Removal of London Stansted LYD 6R/5S SIDS

EGSS LYD SIDs
Stage 4 Update and Submit
Step 4B

Airspace Change Proposal
V1.1

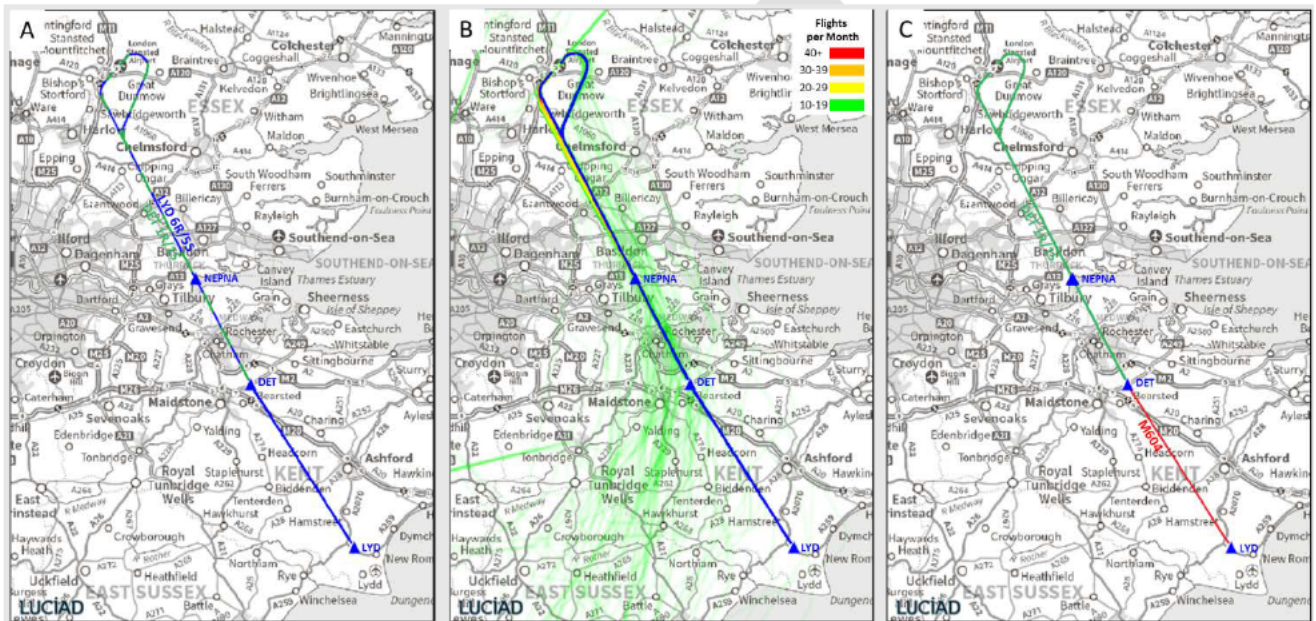
The proposed change is to remove the LYD 6R/5S from the UK AIP, removing the remaining dependency of Stansted instrument flight procedures (IFPs) on the LYD DVOR.

This ACP proposes that aircraft currently departing London Stansted using the LYD 6R/5S SIDs will fly the coincident DET 1R/1S SID. This SID finishes at DET. The remaining portion of the LYD SID will be replicated by extending UK ATS Route M604 from DET to LYD to replace the removed portion of the LYD SIDs. This new segment of M604 will be Route Availability Document (RAD) restricted so that it is only available to those flights which would have flown the defunct LYD 6R/5S SIDs.

These changes will maintain connectivity to the UK ATS network whilst ensuring there will be no changes to the frequency nor to the vertical or lateral dispersion of flights. The current LYD and DET SID routes along with a density plot of aircraft flying the LYD SIDs for June 2019 and proposed changes are shown in Figure 3.

Figure 4: LYD/DET SID Chart AD2.EGSS-6-4 with proposed deletions highlighted red and updates highlighted in green.

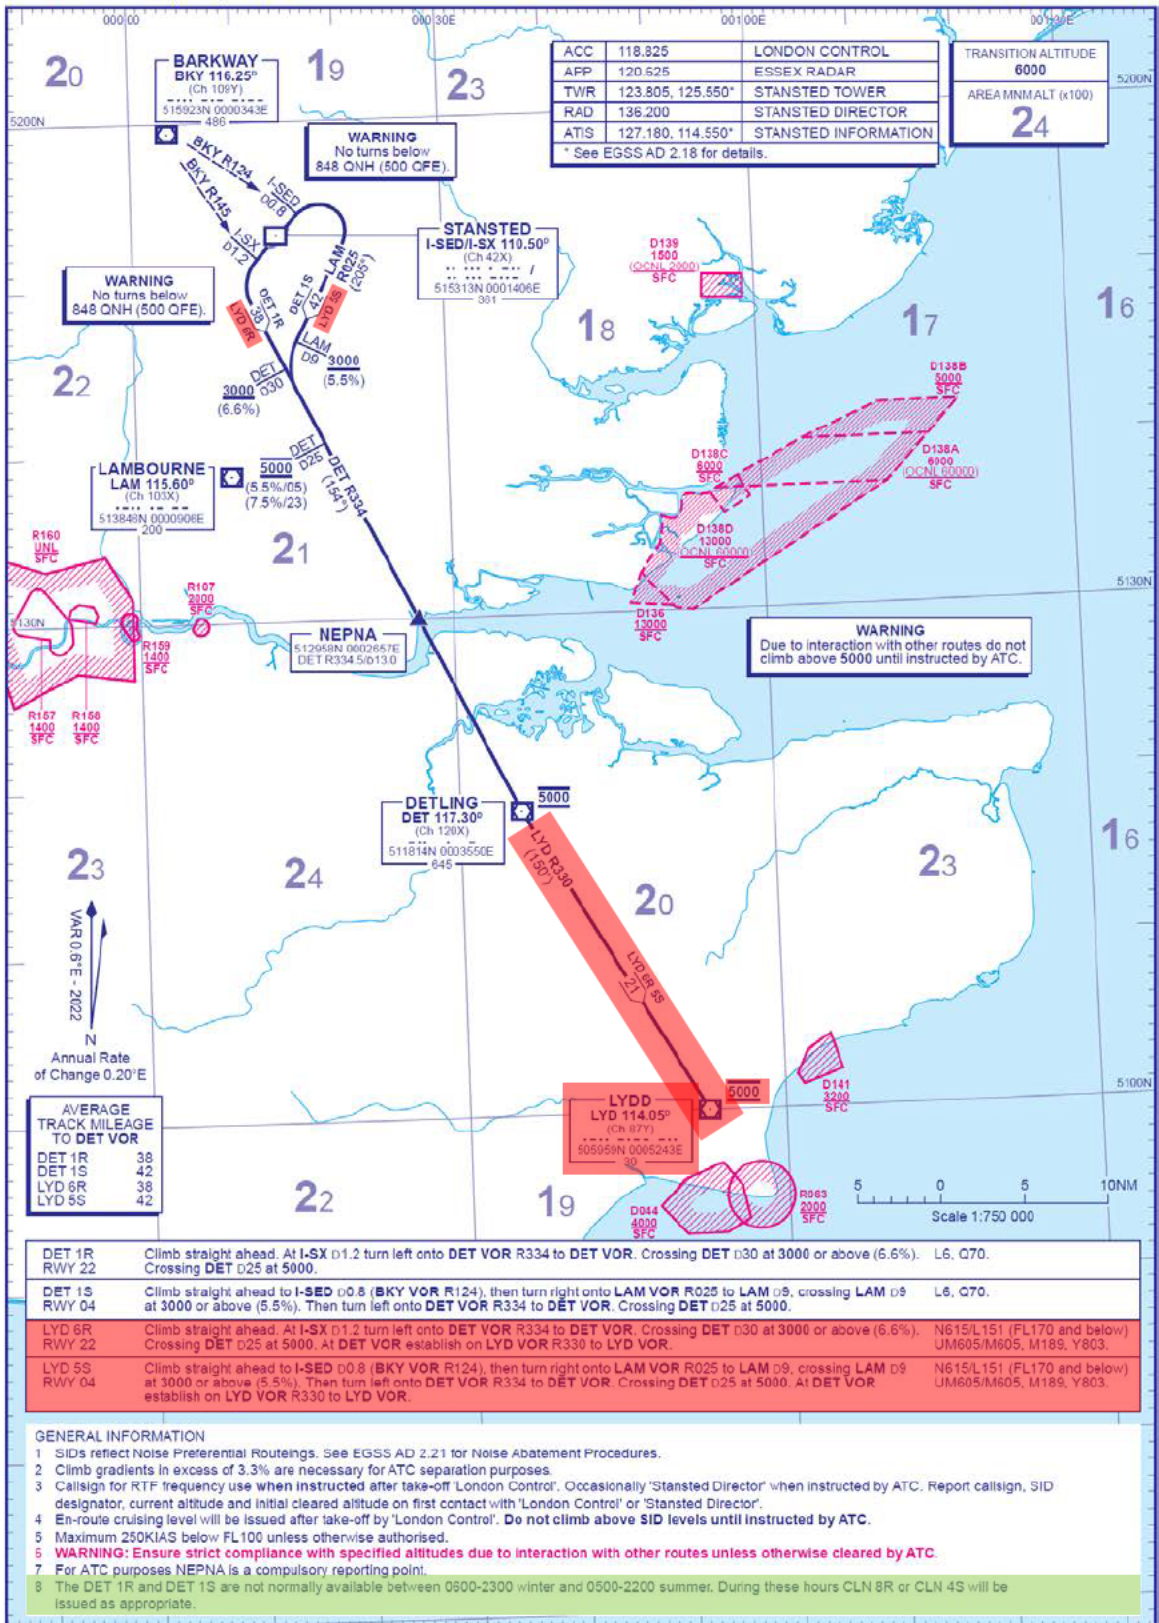
Currently the DET 1R/1S SIDs are not available H24, they are unavailable between 0500-2200 summer and 0600-2300 winter. There is no associated restriction with the LYD 6R/5S SIDs. The DET 1R/1S SIDs availability will be updated to read:

8) The DET 1R/1S SIDs are only available H24, for aircraft departing DET- M604- LYD. For all other departures, the DET 1R/1S SIDs are unavailable between 0500-2200 summer and 0600-2300 winter.

References to the LYD DVOR and LYD SIDs will be removed

The proposed changes to the LYD/DET SID Chart AD2.EGSS-6-4 are shown in Figure 4 below:
